Grove Street Residences – NOI

Grove Street Residences – Wetland Protection Act (WPA)

Grove Street Residences – Major comments addressed 3/28/24

PROPOSED BUILDING 1
SCALE: 1" = 40'

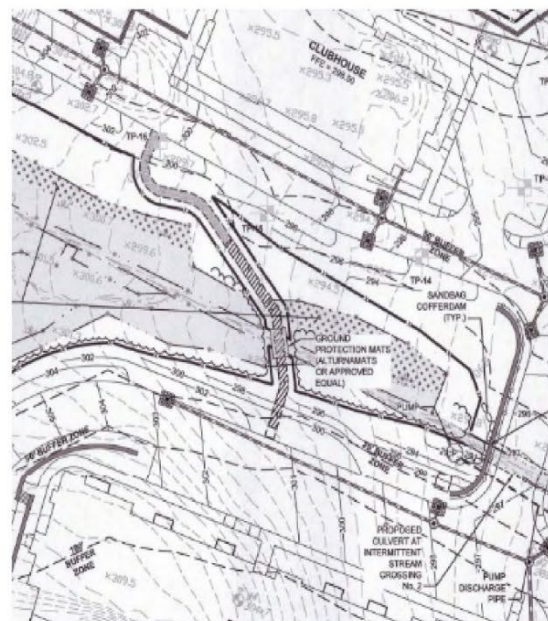
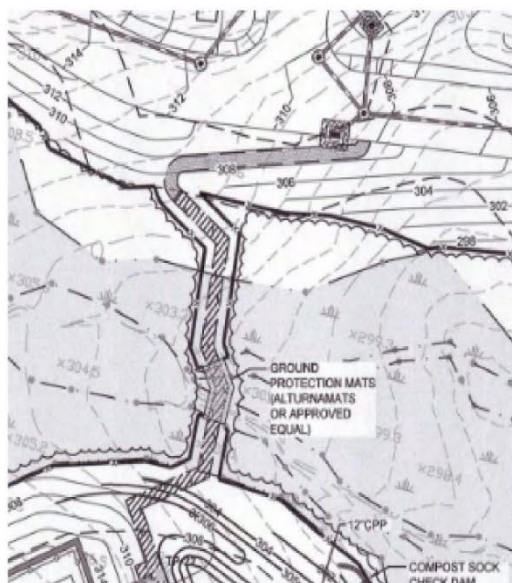
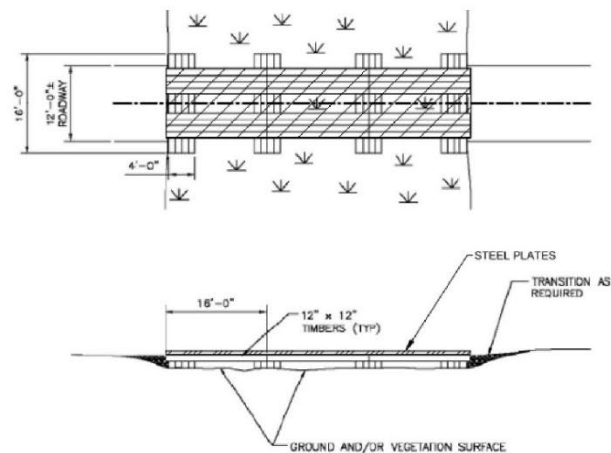
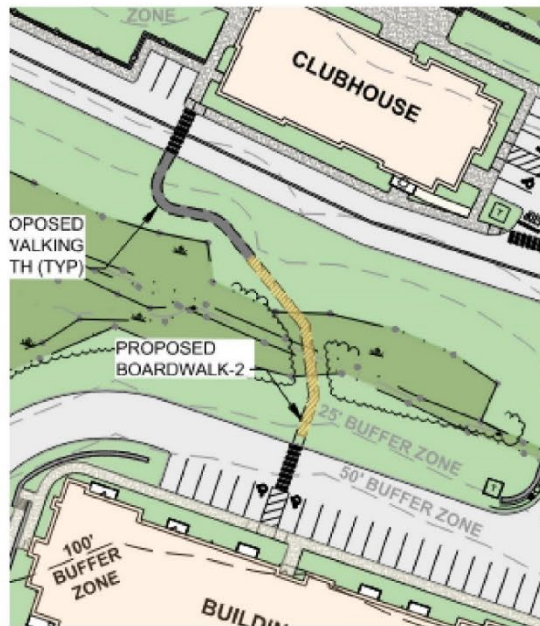
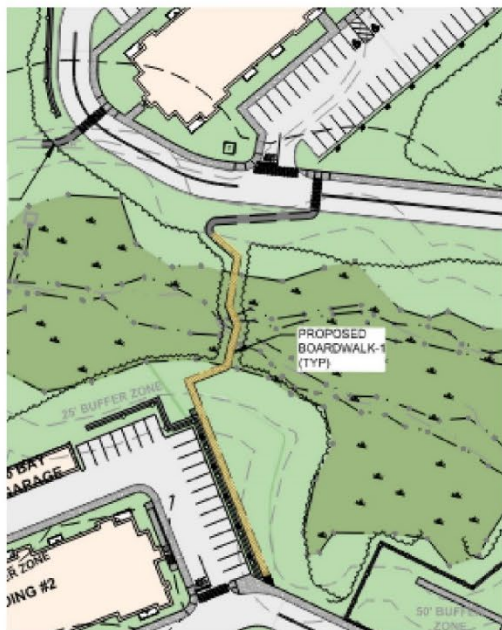
One of two locations where additional tests pits requested

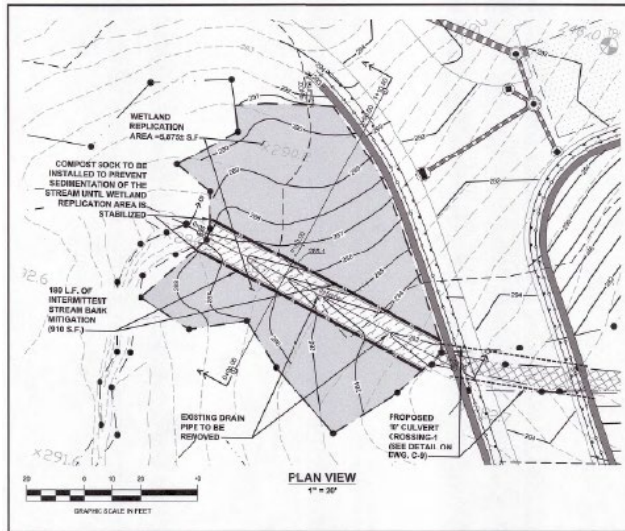
BETA2: Comment partially addressed. Attachment 4 shows the locations where bankfull width measurements were taken in the field at the locations of Intermittent Stream Crossings No.1 and No.2, and the submitted profile depicts how the daylighted stream channel will tie into adjacent existing grades. However, information regarding how the streambed and Banks will be stabilized (temporarily and permanently) and the type/rationale for selection of the streambed substrate within the daylighted channel the stream channel. In addition, it is recommended that staked coir logs of an appropriate diameter be used to establish new Banks.

The Commission could consider including a Special Condition requiring a plan be submitted to the Commission or its Agent for approval prior to the construction of the wetland replication area and stream daylighting efforts which documents:

- A method for stabilization of the Banks associated with the stream daylighting efforts (i.e., coir logs and erosion control netting);
- Specific native seed mix proposed for use along the Bank; and
- Substrate proposed for the streambed.

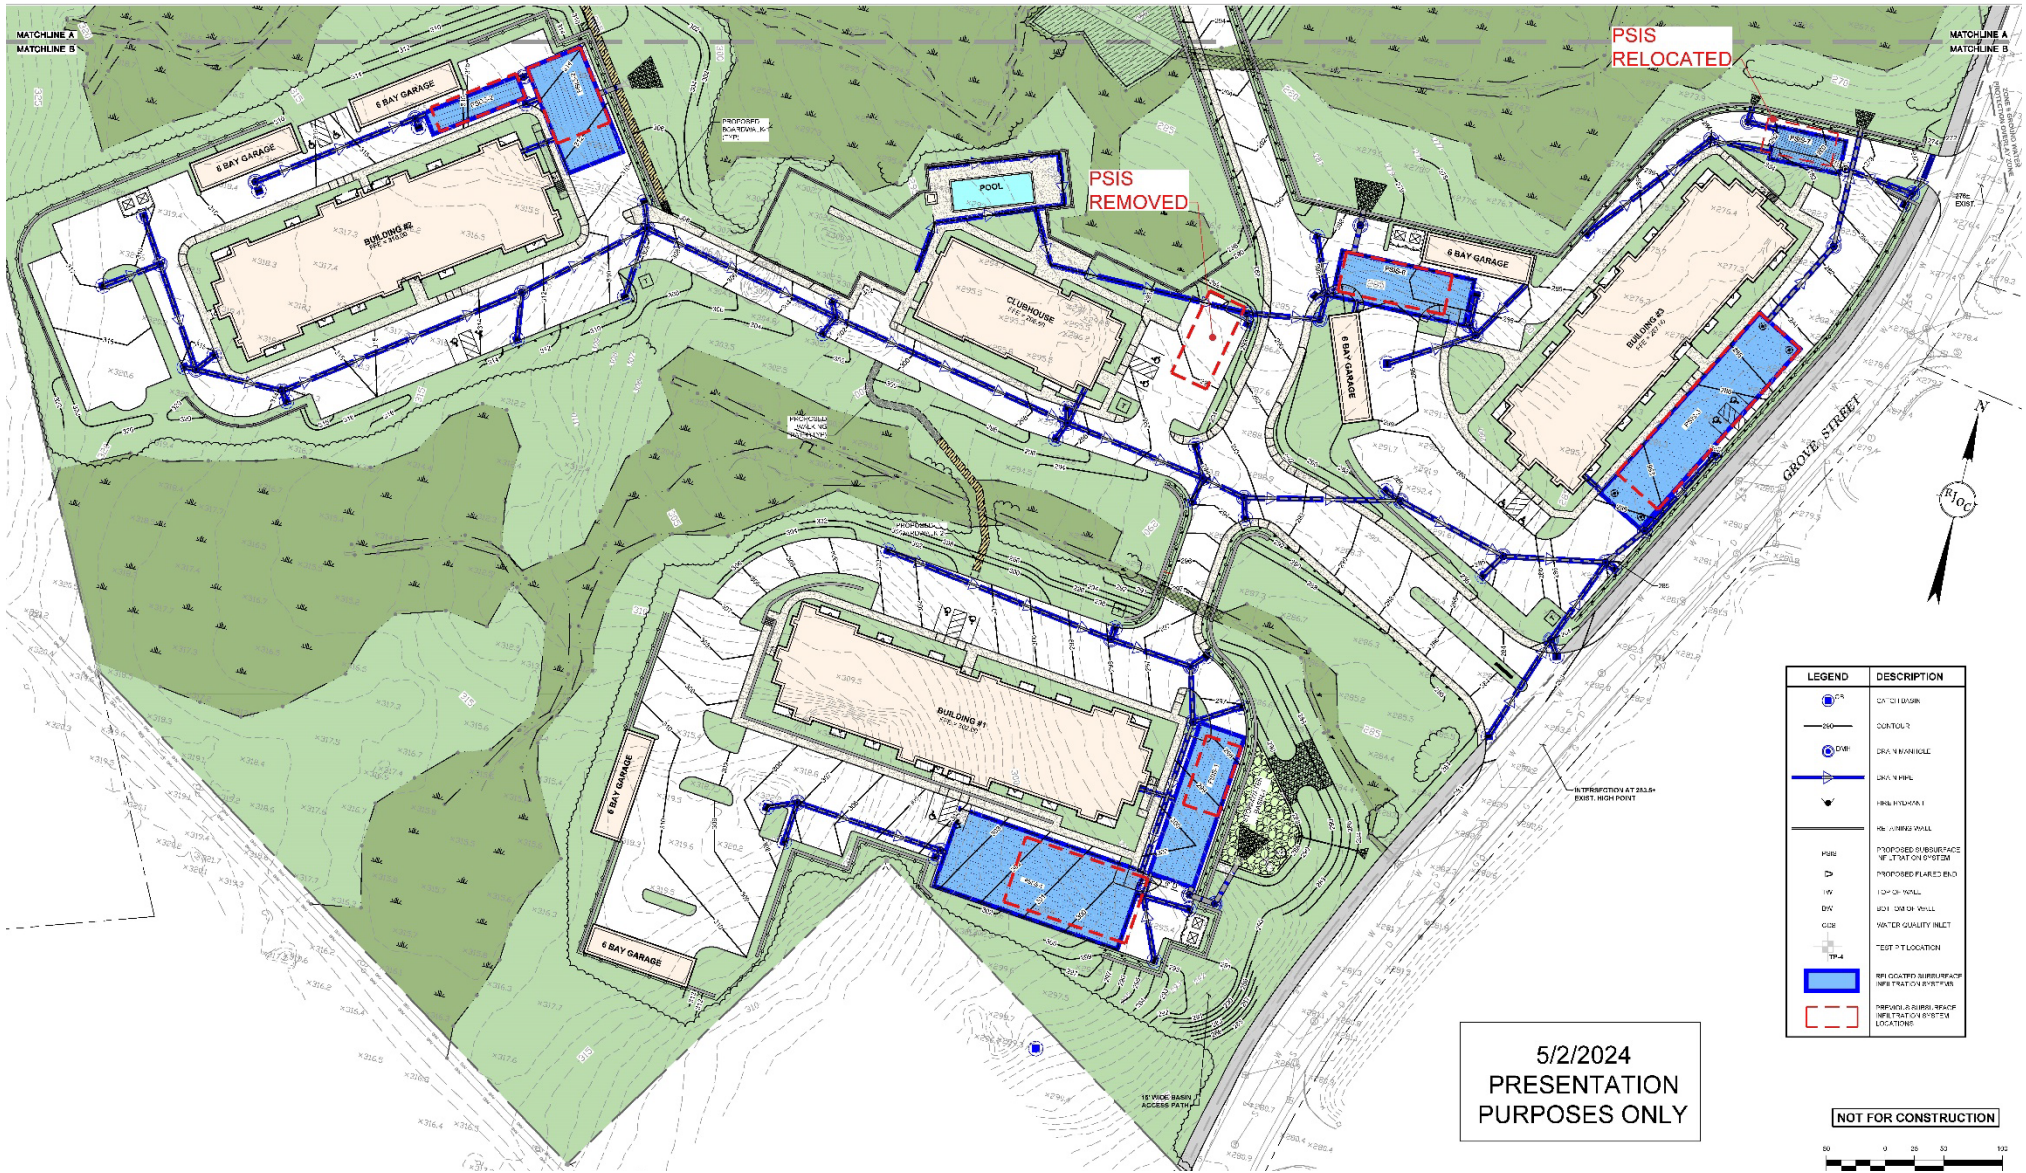
PSIS RELOCATED

PSIS REMOVED

ALL INFILTRATION SYSTEMS MEET OR EXCEED THE REQUIRED SEPARATION FROM GROUNDWATER
